COUNCIL ASSESSMENT REPORT

NORTHERN REGIONAL PLANNING PANEL

PANEL REFERENCE & DA NUMBER	PPSNT-412 – DA25/0123
PROPOSAL	Construction of a seniors housing development consisting of 4 x 3 storey residential flat buildings, including the provision of 91 independent living units, provision of 132 car parking spaces over basement and at-grade level and the construction of 2 communal facility buildings. Additionally, the Development Application seeks approval for earthworks, dewatering, vegetation clearing, internal vehicular roads, pedestrian pathways and landscaping.
ADDRESS	Lot 1 DP 786570 [87-89 Tweed Coast Road, Hastings Point]
APPLICANT	Planit Consulting
OWNER	TriCare (Hastings) Limited
DA LODGEMENT DATE	20 March 2025
APPLICATION TYPE	Development Application (Integrated)
REGIONALLY SIGNIFICANT CRITERIA	Section 2.19, Schedule 6 of <i>State Environmental Planning Policy (Planning Systems) 2021</i> : development that had a capital investment value of more than \$30 million.

PREPARED BY	Ashleigh McLean
DATE OF REPORT	8 August 2025

Figure 29 NSW Biodiversity Values Map - high conservation value areas shaded purple

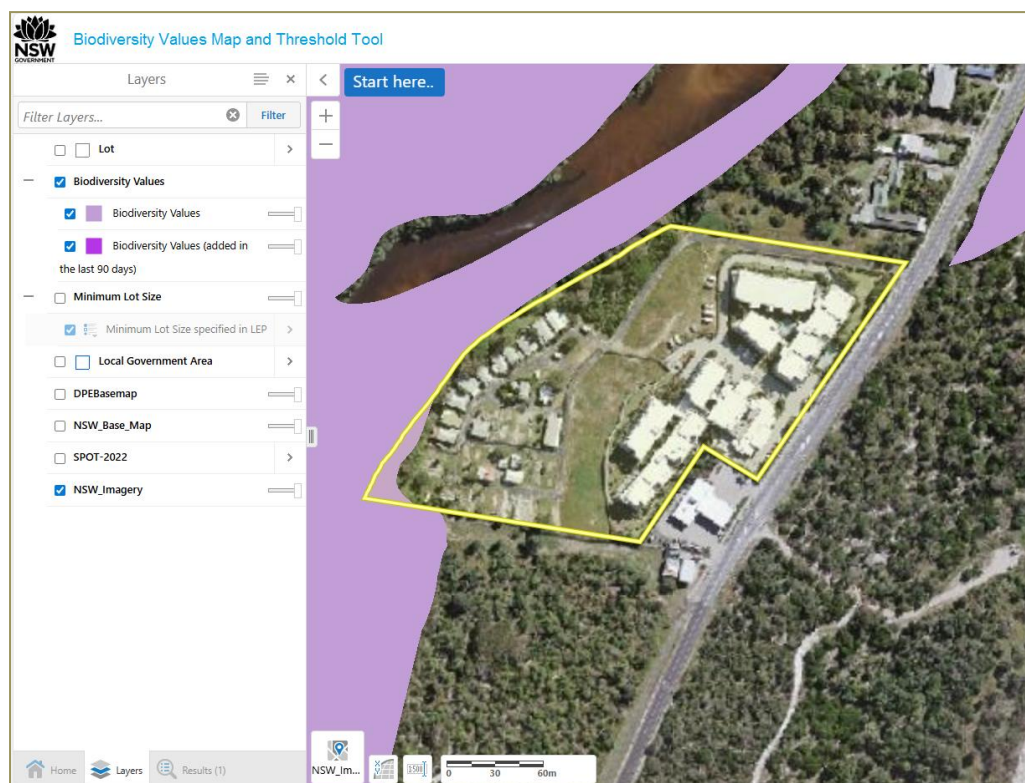
The NSW Biodiversity Values Map (BV Map - Figure 29) made under the *Biodiversity Conservation Act 2016* (BC Act) identifies high conservation value areas (HCVA) onsite being:

The Biodiversity Offset Scheme threshold has been exceeded as the proposal is likely to involve prescribed impacts (related to waterbodies, water quality and hydrological processes) on high conservation value areas identified on the NSW Biodiversity Values Map as a result of predicted groundwater drawdown. As such the application is accompanied by a Biodiversity Development Assessment Report in accordance with Section 7.7 of the BC Act.

Figure 34 Proposed APZ encroachment within the inner red-flagged value ecological buffer zone

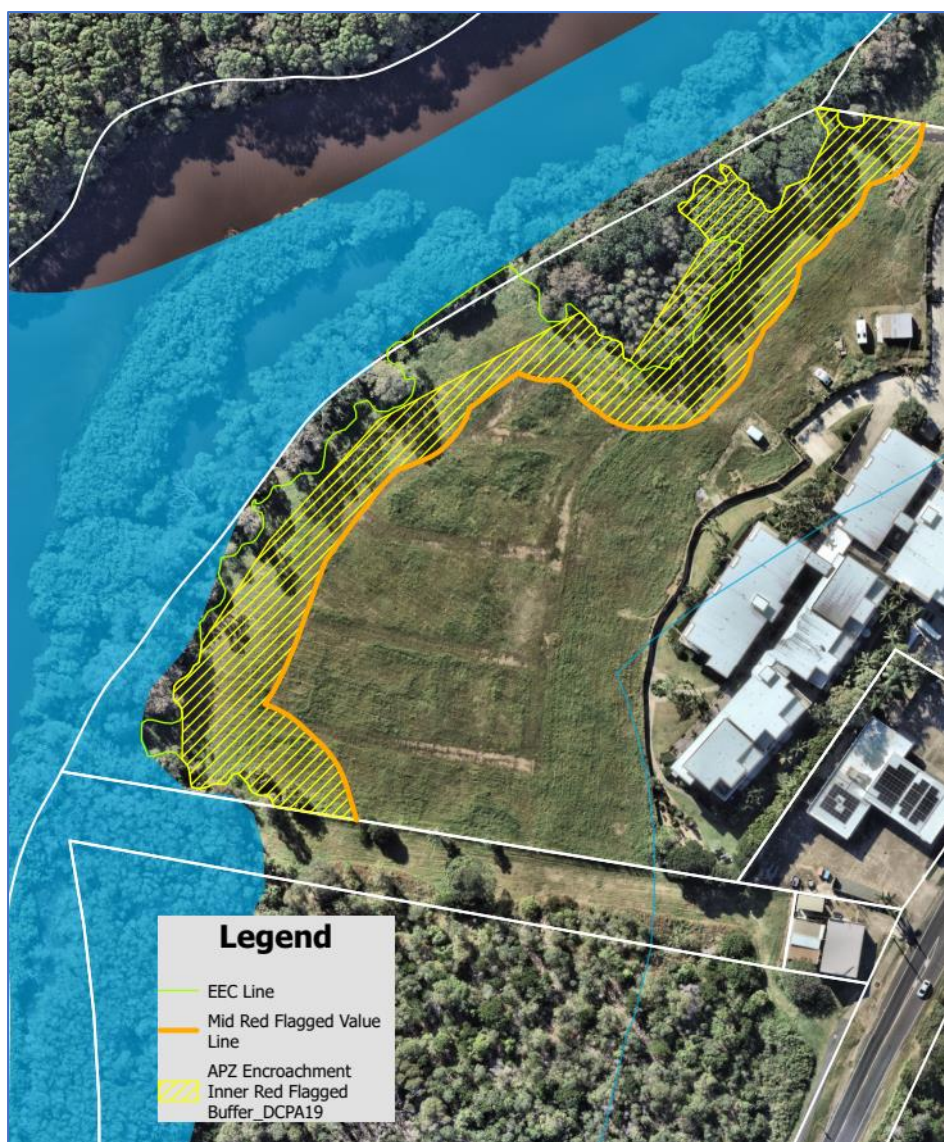
Whilst GTAs have been provided, Council Officers are not supportive of the extent of the required asset protection zones (APZ) within the ecological buffer zone. This is discussed in further detail in a later section in this report. The extent of the required APZ within the ecological buffer zone is illustrated in the figure 34 below.

Figure 37 Red flagged values shaded dark red and DCP A19 Buffer Zones (shaded light red) as take from the BDAR 2025 and overlaid with proposed development features [Buildings D, E and G, asset protection zones (into inner buffer) and emergency access]

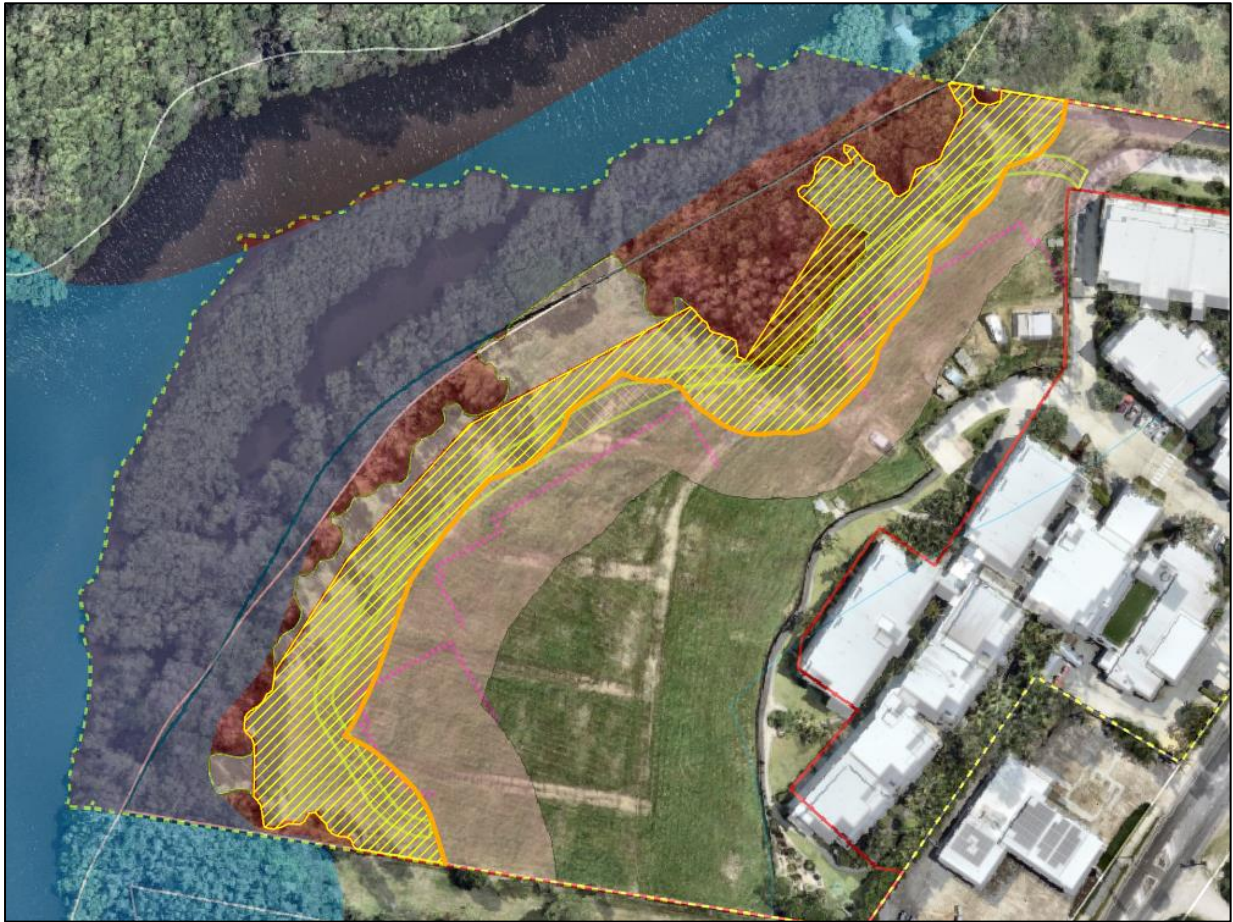
Failure to provide adequate setbacks to the sites red-flagged ecological values (refer to Figure 36) is likely to result in unacceptable and significant adverse environmental impact by restricting the width of the western Cudgera Creek fauna corridor and exacerbating the influence of edge effects post development particularly for those species reliant on riparian vegetation including ecosystem credit species such as Southern Myotis and the Mangrove Honeyeater.

Figure 38 Proposed built form elements extending within the inner red-flagged value ecological buffer zone

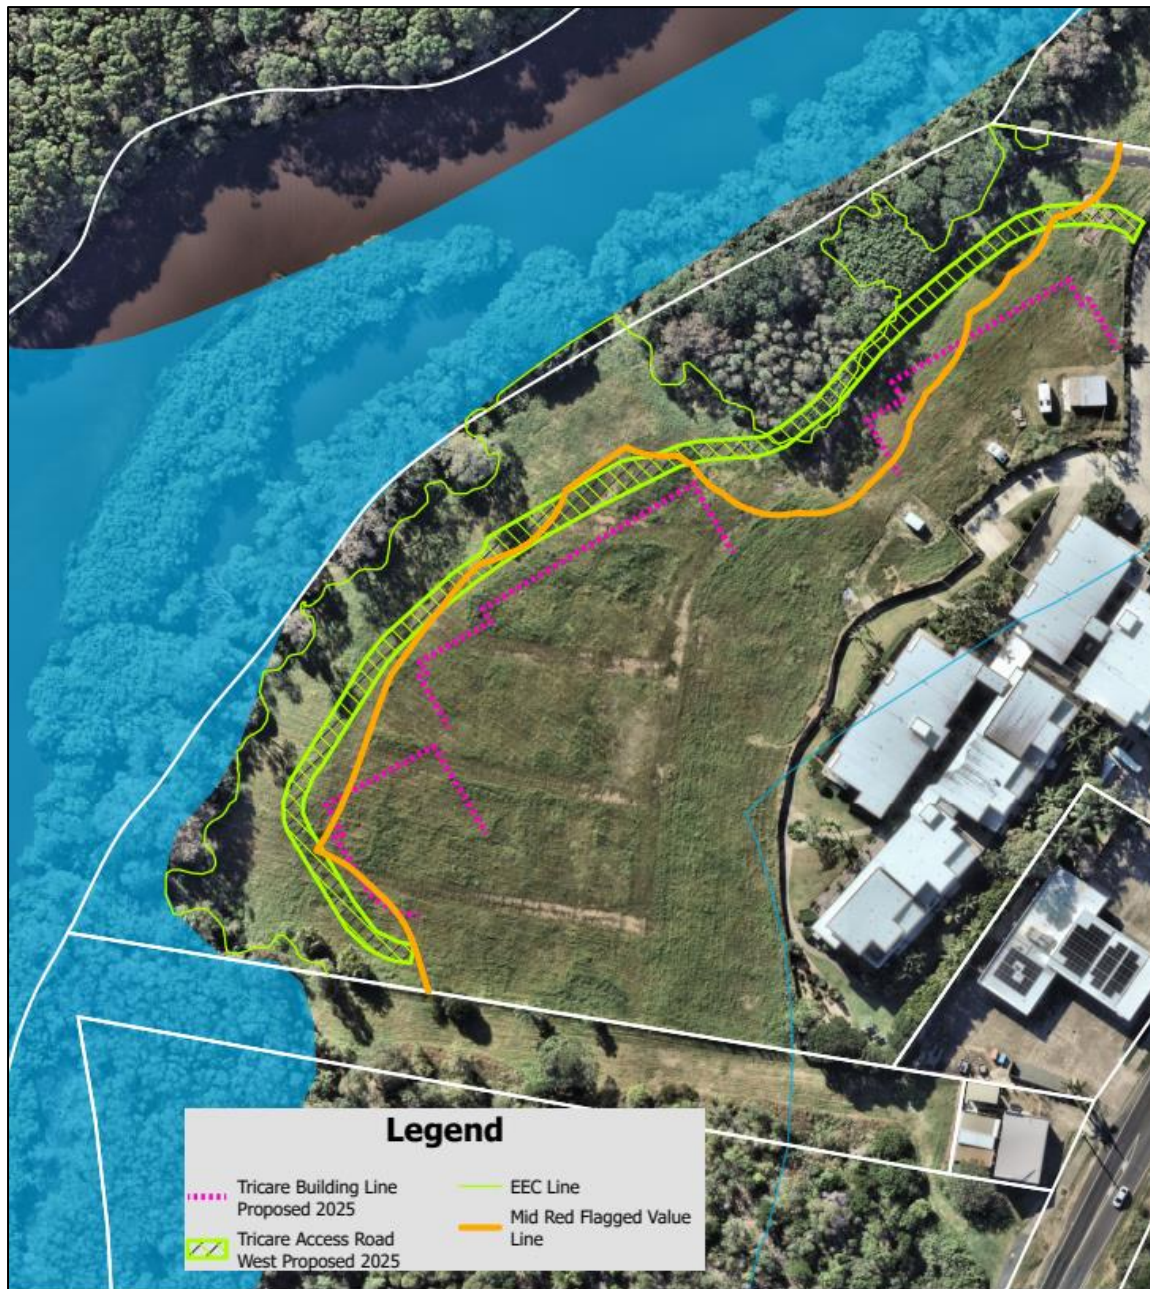
Elements of non-compliance with buffers zones are detailed in Table 15 above and Table 16 below. Features such as the proposed emergency perimeter access road (Figure 38) and asset protection zones (Figure 39) result in direct loss of habitat (latter only), limit the scope and quality of habitat restoration outcomes and result in fragmentation of habitat restoration zones.

Figure 39 Proposed APZ encroachment within the inner red-flagged value ecological buffer zone

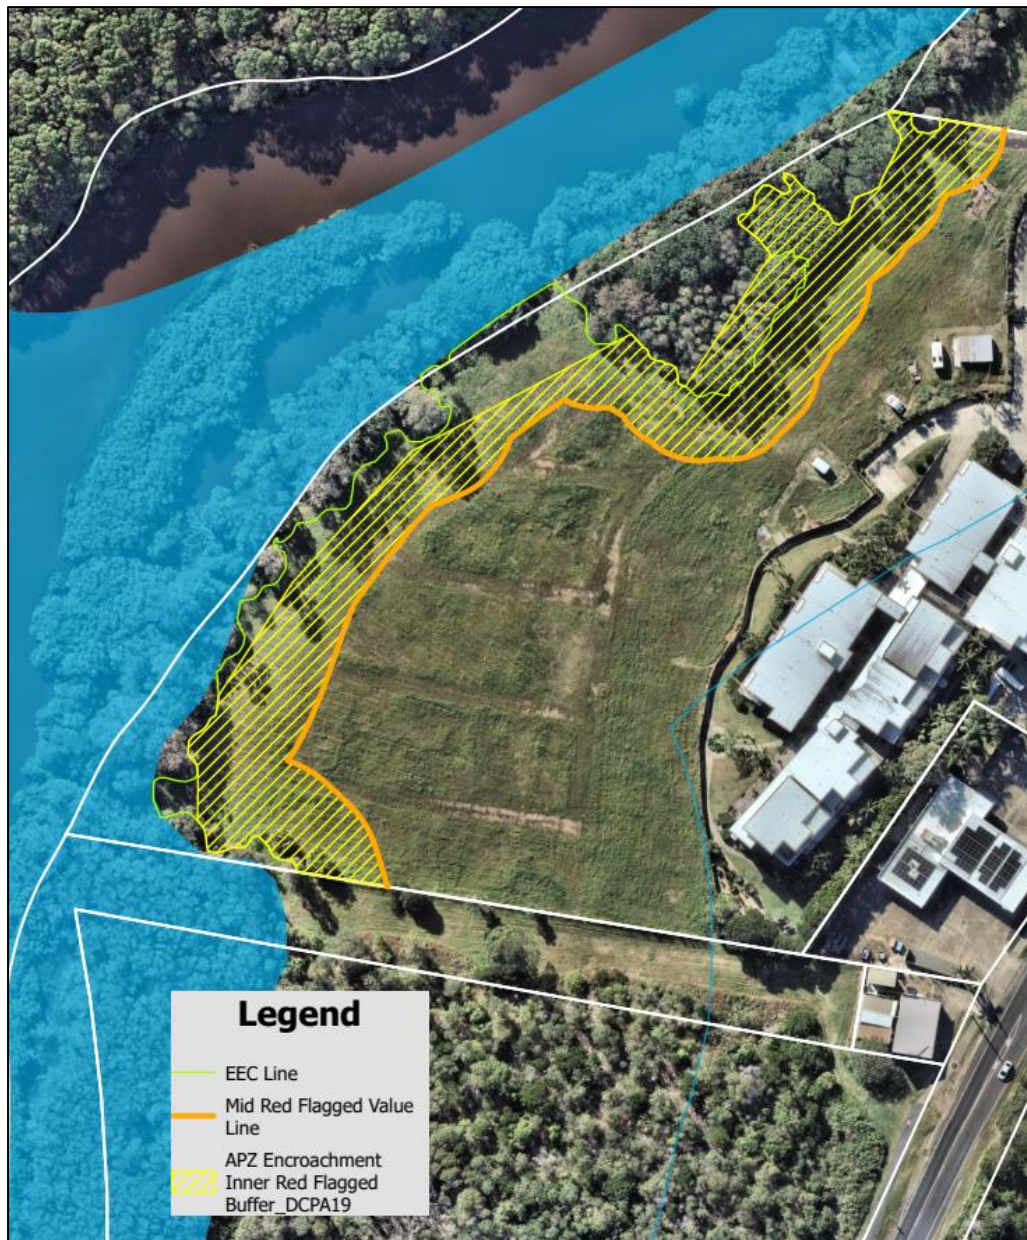
Provisions of *DCP A19 – Development Envelope Control C21* makes an allowance for a bushfire asset protection zone managed as an outer protection area (30% canopy cover and fuel reduced understory) to extend within the outer half of ecological buffer zones. The submitted Bushfire Assessment Report (BAR) proposes to extend an inner protection area (maximum 15% canopy and fuel reduced understory) substantially beyond the outer half of ecological buffer zones applying to the site based on red-flagged values. The extent of asset protection zone encroachment beyond the acceptable limits is depicted in Figure 39 below.

Figure 45 illustrated comparative plan of proposed development layout

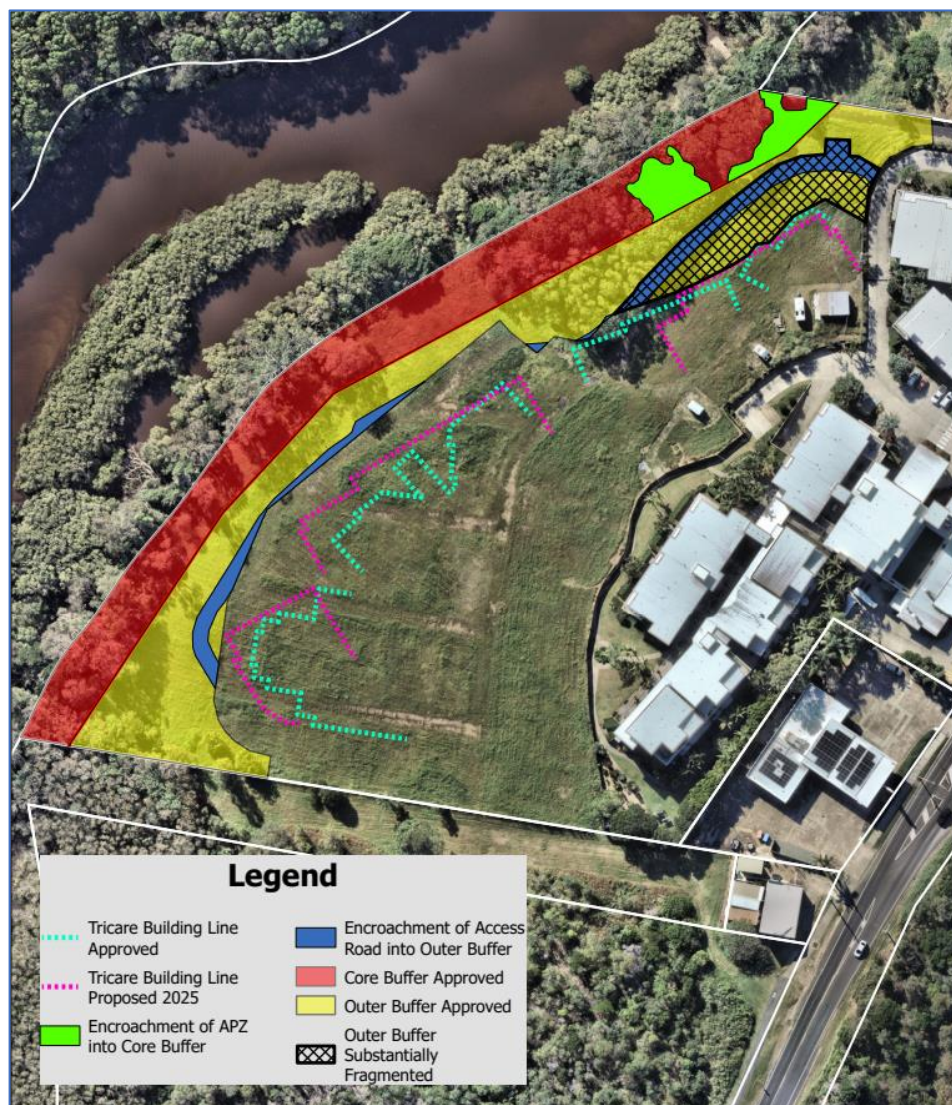
The proposed building envelope results in the direct impact upon red-flagged values onsite, where the impact has not been satisfactorily justified by the Applicant. Council Officers do not support the approved built form under DA06/0413 (as amended) as sufficient justification to avoid consideration to contemporary legislation framework to be considered under s4.15 of the *Environmental Planning and Assessment Act 1979*.
